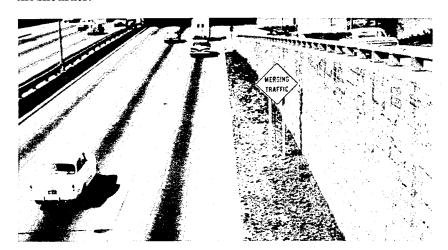
Mr. W. May. Mr. Linko, you had another point. That sign support, the sign 278, could have been located behind that concrete bridge para-

pet on the right?

Mr. Linko. Yes, behind the concrete wall. They always seem to put it someplace where somebody is going to hit it. It could be put behind that, or on the light pole, or in the center divider, putting them back to back. It would save on installation and constant maintenance.
